Circular No. 203/2023

FSCA of Allura Xper, Allura Centron, Azurion and MultiDiagnost-Eleva systems from Philips Medical Systems.

URGENT Field Safety Notice

Allura Xper, Allura Centron, Azurion and MultiDiagnost-Eleva systems.
Potential of the wired and wireless foot switch to become stuck in the active position resulting in unintended radiation.

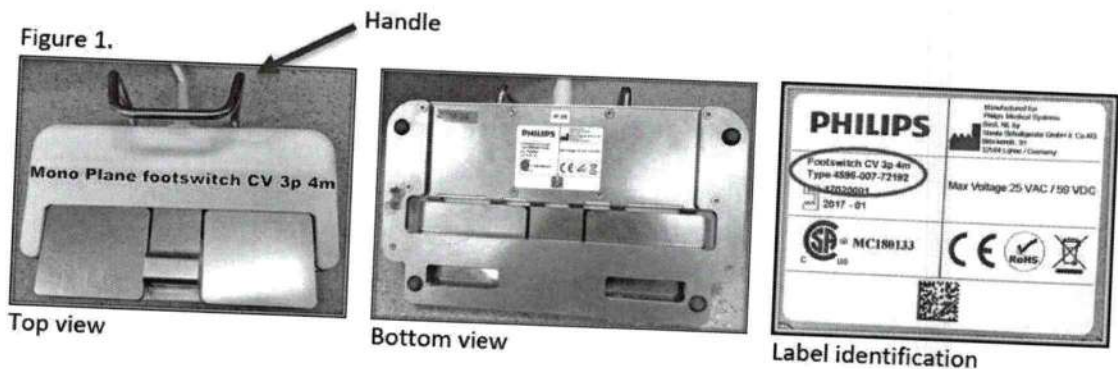
A foot switch pedal may get stuck in the active position when the user releases the pedal, resulting in unintended radiation, because of:

- Build-up of dense or sticky fluids on the foot switch (e.g., blood or contrast fluid), if not properly cleaned.
- Use of protective covers that are either the wrong size or incorrectly placed on the foot switch.
- Dislodgment of a screw holding the pick-up bar (see **Figure 1**) of the foot switch, subsequently becoming lodged within the foot switch housing.
- An additional screw inadvertently left inside the foot switch housing during manufacturing.

The reference/type of the foot switch can be found on the label located on the bottom of the foot switch, as shown in Figure 1.

- In accordance with the Instructions for Use ("IFU") Addendum attached to this letter:
 - Clean the foot switch to remove any dense or sticky fluids.
 - Use a cover bag to protect the foot switch against debris during surgical procedures.
- Continue using a cover bag and cleaning the foot switch in accordance with the frequency requirements provided in the IFU Addendum.

- Inspect the handle of the foot switch to ensure that it is securely attached and has not become loose. If the foot switch handle has become dislodged, stop using the foot switch and contact Philips for a foot switch replacement.
- Follow the instructions in the attached IFU Addendum for handling the foot switch. Specifically:
 - **Only** use the handle of the foot switch to lift and reposition it.
 - Do **not** step or stand on the handle.
- Keep this Field Safety Notice letter and the IFU Addendum with the documentation of the system.
- Please complete and return the attached response form to Philips promptly and no later than 30 days from receipt. Completing this form confirms the receipt of the Field Safety Notice letter and understanding of the issue and required actions to be taken.
